APPLICANT:	LAI Engineering	PETITION No.:	V-35
PHONE:	770-423-0807	DATE OF HEARING:	05-09-12
REPRESENTA	TIVE: C. Doug Day	PRESENT ZONING:	GC
PHONE:	770-423-0807	LAND LOT(S):	28
TITLEHOLDE	R: Leon Reeves and Herchel E. Cook	DISTRICT:	19
PROPERTY LO	On the southeastern	SIZE OF TRACT:	1 acre
corner of Dallas Highway and Villa Rica Way		COMMISSION DISTRICT: 1	
_	No. OPPOSED PETITION No PEALS DECISION	SPUKESMAN	
_	No. OPPOSED PETITION No PEALS DECISION	SPOKESMAN	
REJECTED	MOTION BYSECONDED	329 CRC	GC
HELD CA	-	Dallas Hwy Dallas Hwy GC GC GE	Old Childra Rig
	-	R-20

Application for Variance Cobb County

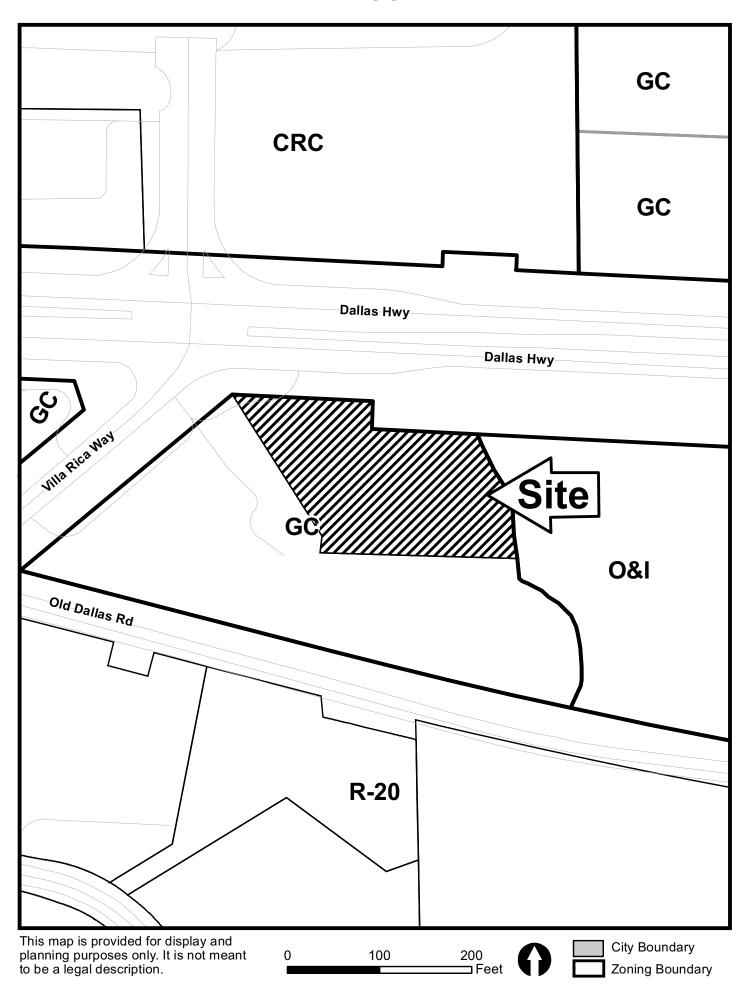
STORMWATER MANAGEMENT: All the proposed improvements are located above/outside the 100-year floodplain; however, there is significant encroachment into the adjacent stream buffer. The dumpster enclosure, a small portion of the last parking space, the dumpster approach and sidewalk are located in the 75-foot undisturbed stream buffer (~370 square feet). Approximately 1,900 square feet of impervious surface, including the corner of the building, the dumpster pad and the last 2 ½ parking spaces and associated drive and walkway, are within the 25-foot impervious setback (from the undisturbed stream buffer). The plan should be revised to eliminate these encroachments.

DESIGN GUIDELINES: This property is within the boundaries of the Dallas Highway Design Guidelines. The guidelines state the following concerning the location of dumpsters: "Areas to be located at the rear of building and not visible from public view. Should be screened/enclosed with a wall at a height of 6 feet and constructed of masonry with metal or wood gates." The applicant may be subject to further compliance with the Dallas Highway Design Guidelines at Site Plan Review.
